City of Oakley
ADDENDUM NO. 1 to contract documents for
OAKLEY COMMUNITY DOG PARK – PHASE 1 PARKING LOT
PROJECT, CIP # 197

BID OPENING DATE: June 29, 2017 2:00 PM

Notice is hereby given that the following clarifications and revisions are made to the above referenced contract documents:

V:\\$4001 - Current\4252 - Dewey Park\4252 E1.0.dwg

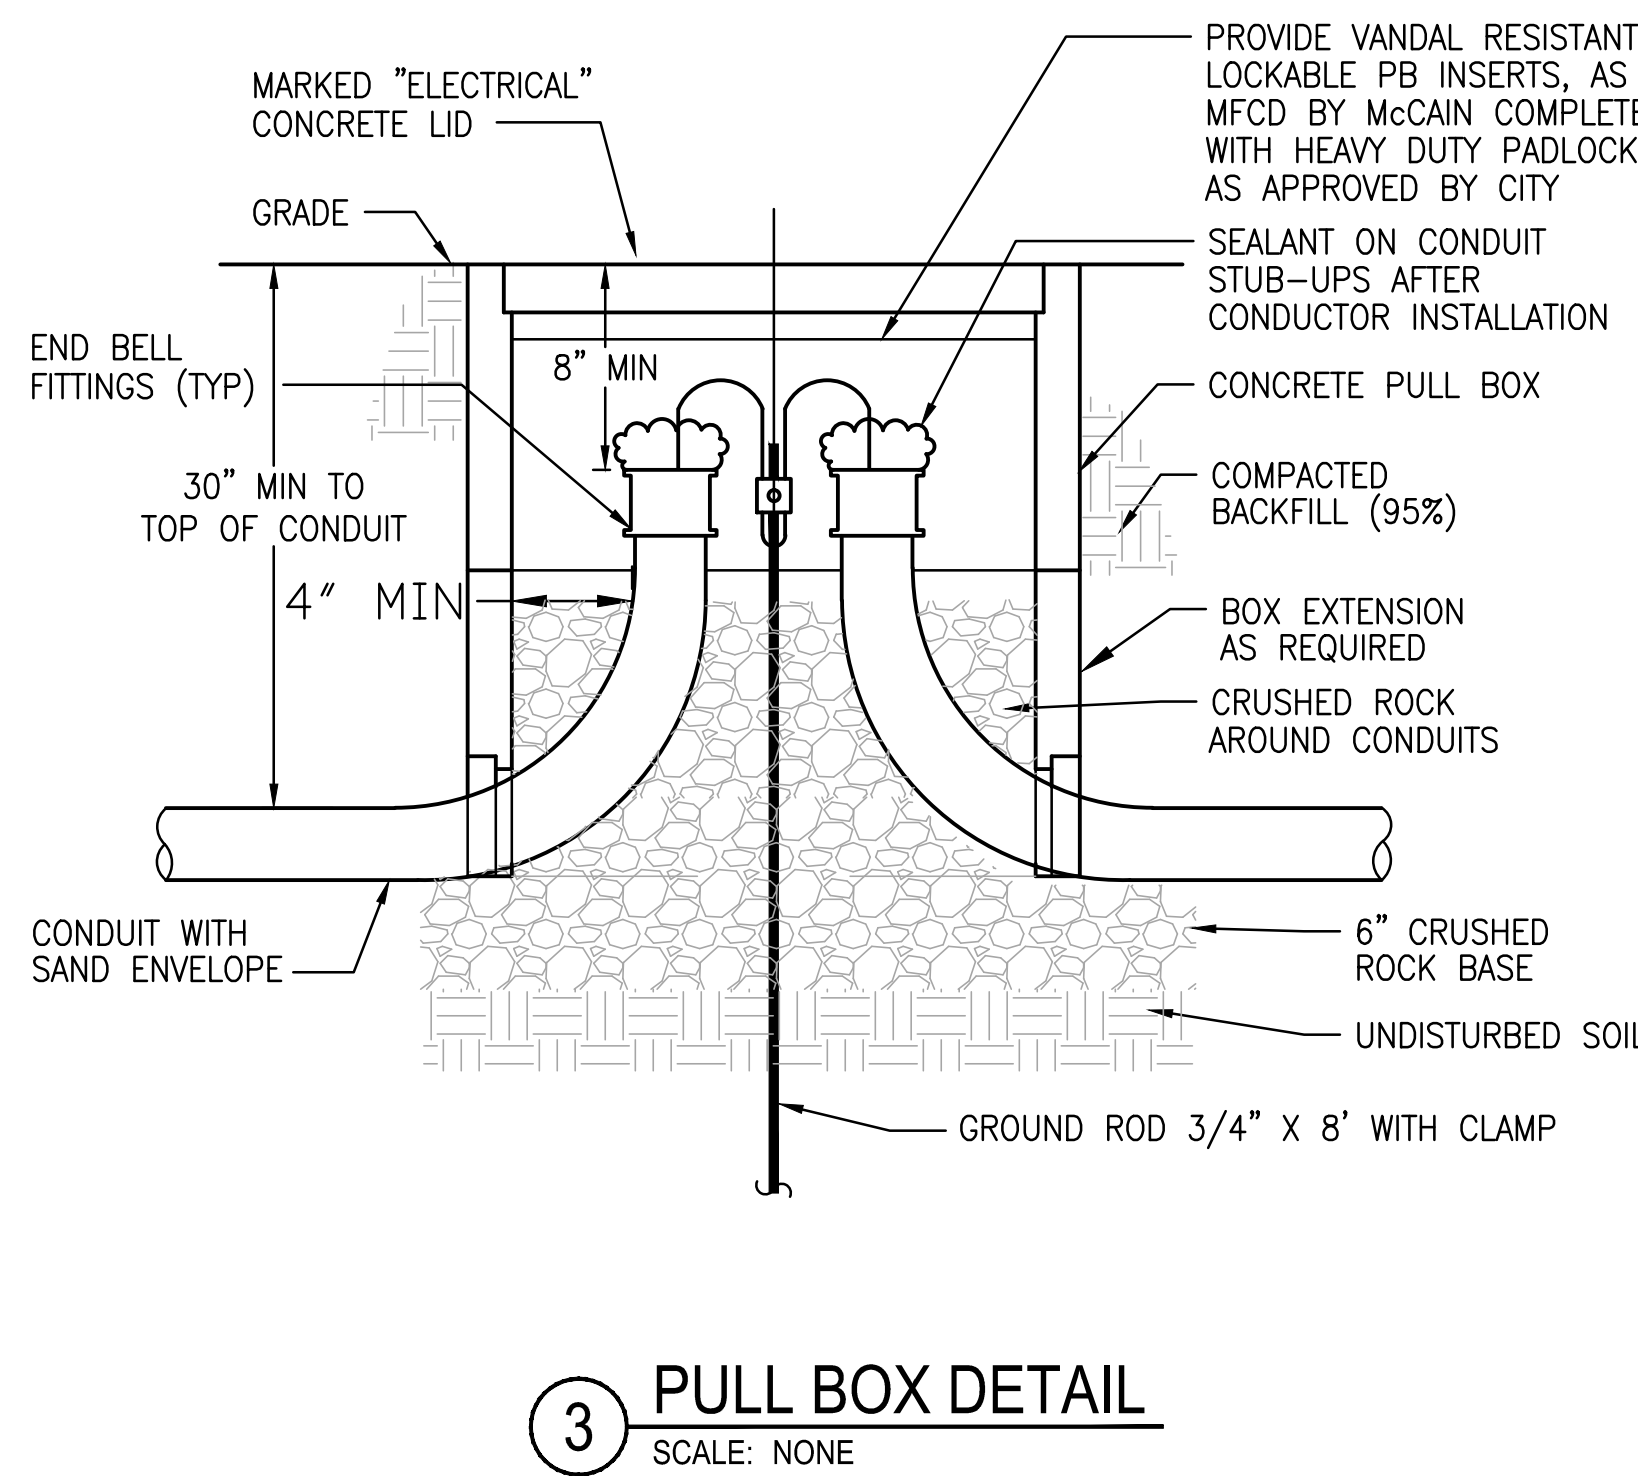
Sheet E1.0 & E2.0

- o Electrical single phase updated to 3 phase converter for the PG&E electrical connection, as shown on pages E1.0-2.0. The service is shown on the drawing at 200 amp 120/208 volts three phase four wire, which will be able to handle any changes in the hp rating of the motor.
